Planning Proposal - Deferred Area 15 - Killara Golf Club

PLANNING PROPOSAL - DEFERRED AREA 15 - KILLARA GOLF CLUB

Planning Proposal – Consideration and required amendments

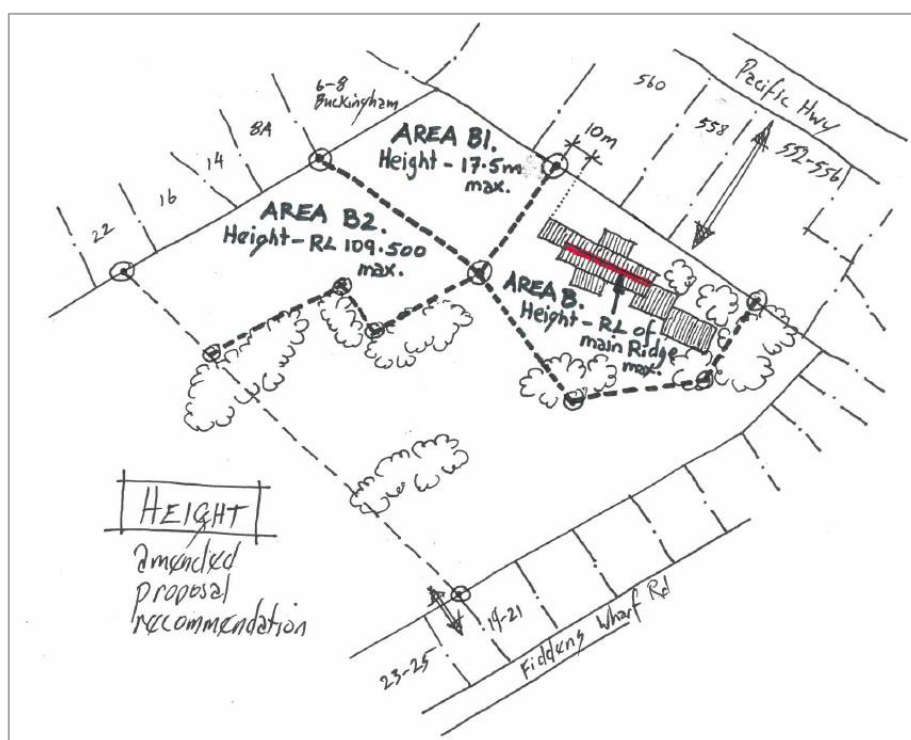
As a result of the recommended adjustment to boundaries for zoning and differing heights to Areas B, B1, B2 within the R4 (High Density Residential) area, calculations are to be undertaken by the applicant to establish the site FSRs based on the zoning and height areas recommended in this Council report and in the *Table of Amendments* at **Attachment A1**. The evidence and numerics of the FSR calculations must also be provided to enable verification by Council.

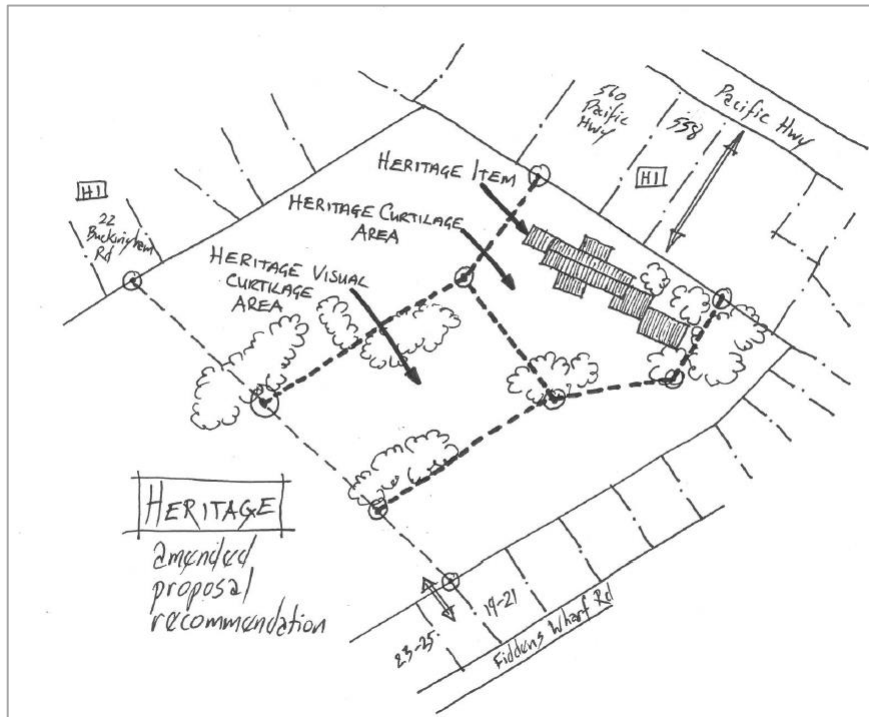
The north-west corner of the proposed R4 (High Density Residential) zone abuts an existing R2 (Low Density Residential) zoned area which includes the Heritage Item I257 at 22 Buckingham Road. To have R4 (High Density Residential) immediately adjacent to an R2 (Low Density Residential) zoning creates an interface issue as discussed above in this Council Report. It is Ku-ring-gai Council's practice to generally (where possible) step down the built form bulk and scale through appropriate transitional zoning, or height/FSR standards within an interface site to reduce amenity impacts such as overshadowing and loss of privacy that result from R4 (High Density Residential) 5-storey buildings being adjacent to R2 (Low Density Residential) 2-storey buildings.

Reducing the maximum building height of the site immediately adjacent the 22 Buckingham Road Heritage Item from an RL109.810 to RL109.500 will ameliorate some of the impacts from having an incompatible zoning immediately adjacent to the Heritage Item.

Figure 1: Recommendation for zoning amendments to the Planning Proposal

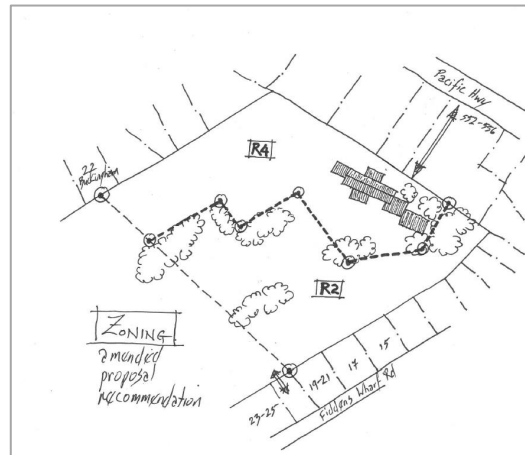
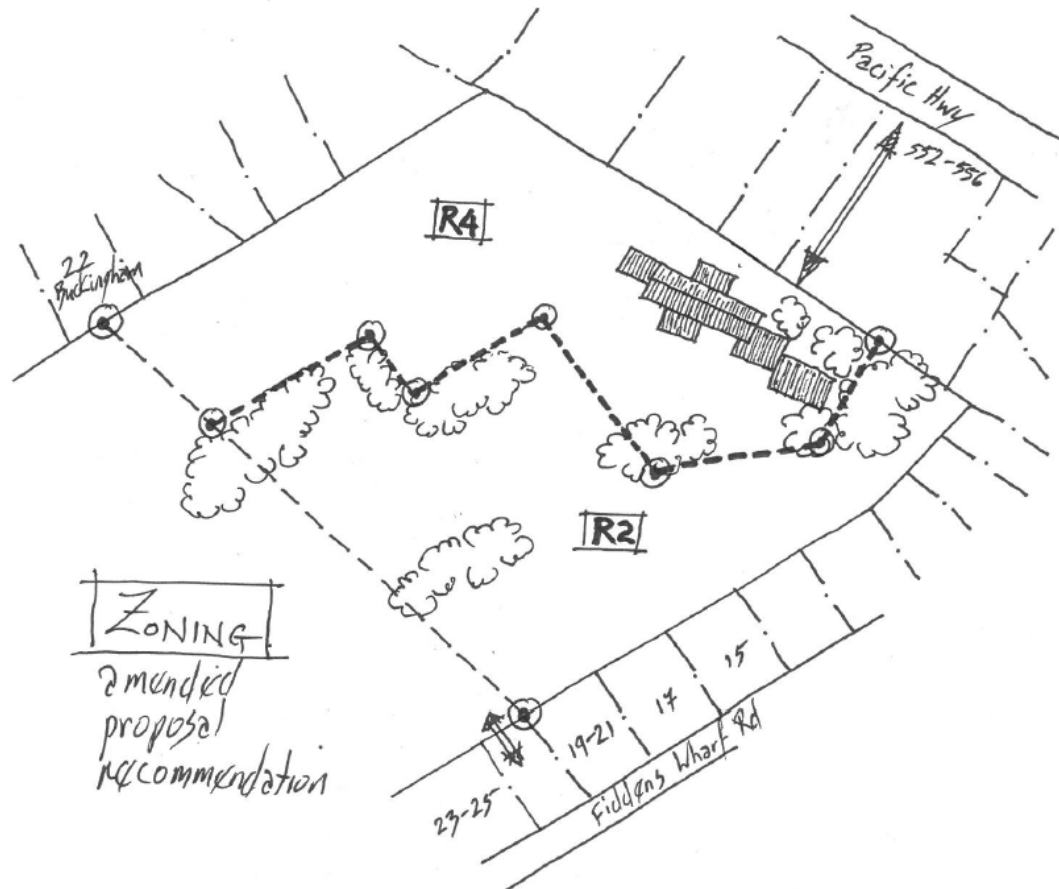
1. Amend the Planning Proposal as stated in the *Table of Amendments* at **Attachment A1** to ensure clear, correct and content consistent with Council's approach to land use planning is presented for Gateway Determination and for public exhibition.
2. Amend the Zoning Map boundary lines for the split R2 (Low Density Residential) and R4 (High Density Residential) zoning as required in this Council Report and the *Table of Amendments* at **Attachment A1** and depicted in *Figure 1* below.

Figure 2: Recommendation for height amendments to the Planning Proposal

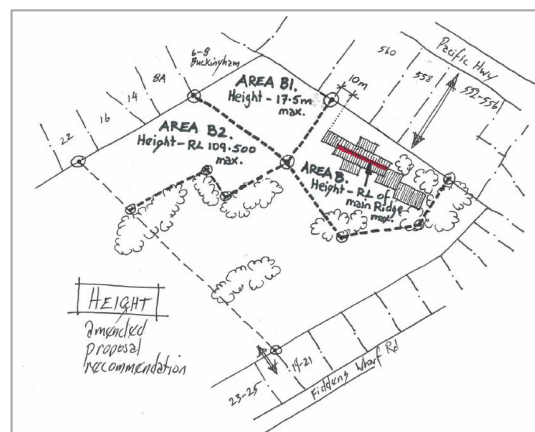
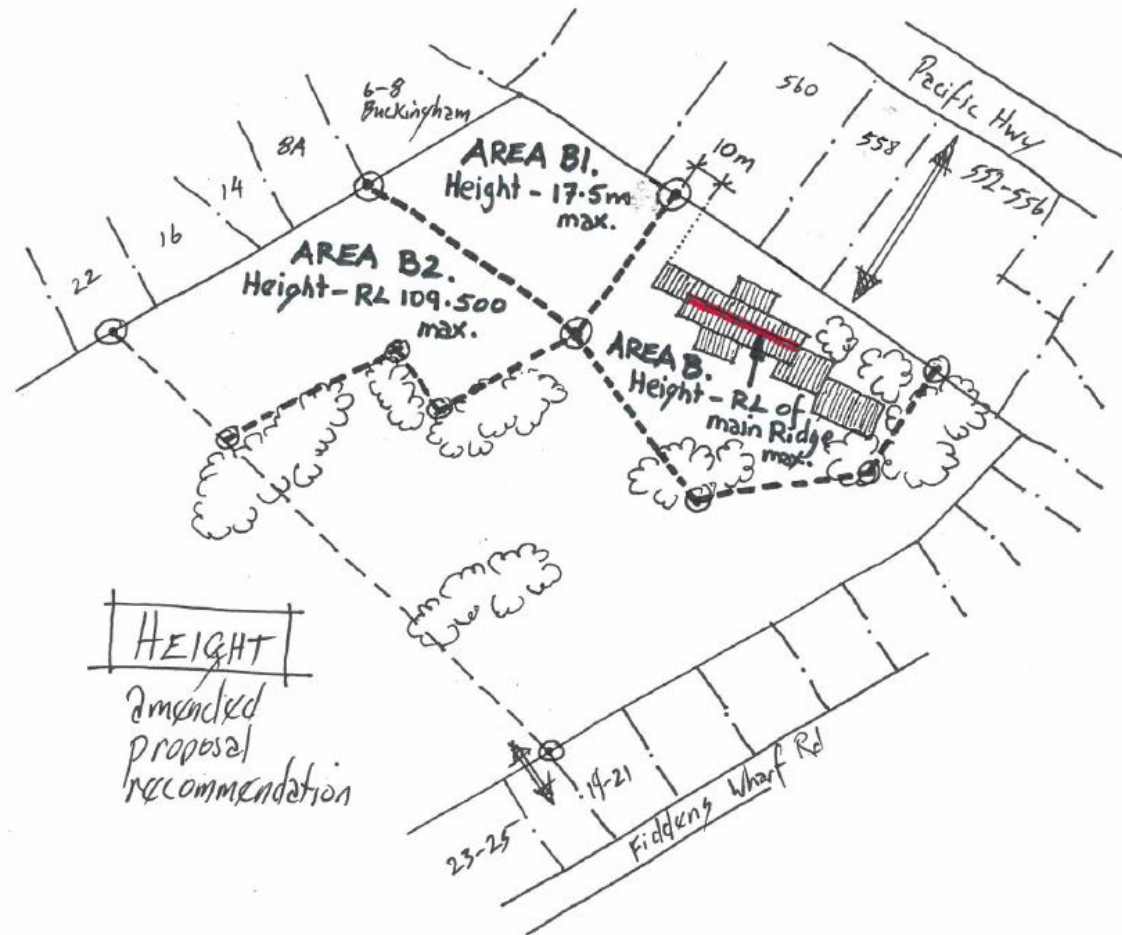
3. Amend the Building Height Map boundary lines to include the following standards and detail as required in this Council Report and the *Table of Amendments (Attachment A1)* and depicted in *Figure 2* below:
 - R4 (High Density Residential) area with height of RL 109.500 from the corner boundary point between 8A Buckingham Road and 6-8 Buckingham Road to the corner point of the Heritage Curtilage Area and the Heritage Visual Curtilage lines (referred to as Area B2 in this Council Report);
 - R4 (High Density Residential) area with height of maximum 17.5m (referred to as Area B1 in this Council Report);
 - R4 (High Density Residential) area with height of maximum RL equivalent to the main roof ridgeline of the Heritage Item Clubhouse running NW-SE (referred to as Area B in this Council Report).

Management Plan (CMP) (page 74) as Curtilage A be limited to an RL equivalent to the main roof ridgeline (running NE-SW) of the clubhouse. This potentially permits adaptive reuse of the clubhouse while not supporting 5-storey development within the immediate curtilage of the Heritage Item.	
8-9	Part 2 – Explanation of Provisions <i>Zoning Map</i>	The north-west corner of the proposed R4 (High Density Residential) zone abuts an existing R2 (Low Density Residential) zoned area which includes the Heritage Item I257 at 22 Buckingham Road Killara. To have R4 (High Density Residential) immediately adjacent to an R2 (Low Density Residential) zoning creates an interface issue. It is Ku-ring-gai Council's practice to generally (where possible) step down the built form bulk and scale through appropriate transitional zoning or height/FSR standards within an interface sites to reduce amenity impacts such as overshadowing and loss of privacy that result from R4 5-storey buildings being adjacent to R2 (Low Density Residential) 2-storey buildings. Limiting the Maximum Building Height of the site immediately adjacent the Heritage Item to RL109.5 will ameliorate some of the impacts from having an incompatible zoning immediately adjacent to the Heritage Item at 22 Buckingham Road.	• Reduce the Maximum Building Height of the site immediately adjacent the Heritage Item at 22 Buckingham Road Killara from an RL of 109.810 to 109.500 (see Figure 2).

Figure 3: Recommendation for heritage amendments to the Planning Proposal

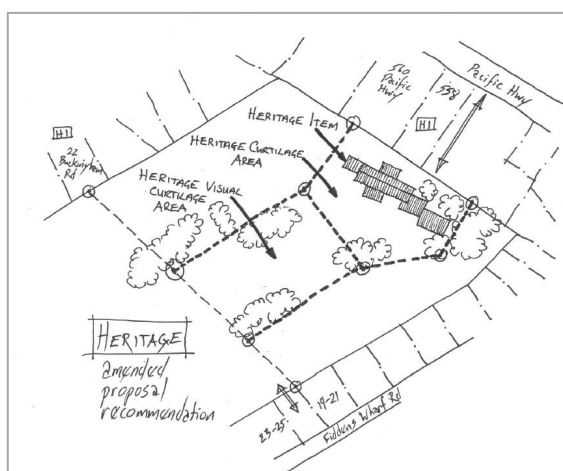
4. Amend the Heritage Map boundary lines to include the two heritage curtilage area lines as per the Planning Proposal with the amendment stated below and as required in this Council Report and the *Table of Amendments (Attachment A1)*, and depicted in *Figure 3* below:

- Heritage Visual Curtilage Area and Heritage Visual Curtilage Area (view corridor) lines to include the two groups of trees on the southern boundary of the proposed Heritage Item (between the 1st and 18th holes) being H1 202-209, H18 160-164 and H1 188-200. Extend the boundary of the Curtilage Area and Visual Curtilage Areas to the edge of the dripline of these trees.

<i>Zones</i>	<i>"A Flora and Fauna Study has been undertaken by Footprint Green P/L and this study supports the proposal."</i> does not explain how the study supports the proposal. It is not a sufficient argument to point to the content of a study/report. The evidence and explanation of how the study supports the Planning Proposal must be detailed in the body of the Planning Proposal by drawing out and quoting evidence and conclusions from the study.	conclusions from the supporting studies within the body of the Planning Proposal.
17-18	Part 3 Justification <i>Relationship to strategic planning framework</i> <i>Direction 2.3 Heritage Conservation</i>	The objective is to conserve Heritage Items, this includes curtilage. The proposed curtilage for the clubhouse based on the assessment <i>Conservation Management Plan by GBA</i> is considered to be insufficient. The nominated curtilage of the Heritage Item which includes a significant view corridor fails to include two groups of trees close to the club house (see Fig. 3). Many of these trees have previously been assessed by Council in the assessment of DA0147/11 as having significant aesthetic value to the setting of the Heritage Item. The two groups of trees are on the edge of the fairway of Hole 1 and include hoop pines and bunya pines. Visually they act as a frame to the proposed visual curtilage. As explained in the publication <i>"The Killara Golf Club"</i> by Earle Bastian (1999, p9): <i>"Tree planting is done for a number of reasons, from influencing strategy of play to defining holes and adding charm, shelter and windbreaks...once chosen trees are placed so as to allow vistas...and to give a natural rather than artificial or geometric look to the course"</i>. For these reasons the visual curtilage should include the specified trees to retain the Heritage Item's setting.	Expand the mapped area for the Heritage Item on the proposed Heritage Map (p.10) to include the two groups of trees on the southern boundary of the proposed Heritage Item (between the 1st and 18th holes) being H1 202-209, H18 160-164 and H1 188-200. Extend the boundary of the Curtilage Area and Visual Curtilage Area s to the edge of the dripline of these trees (see Figure 3).
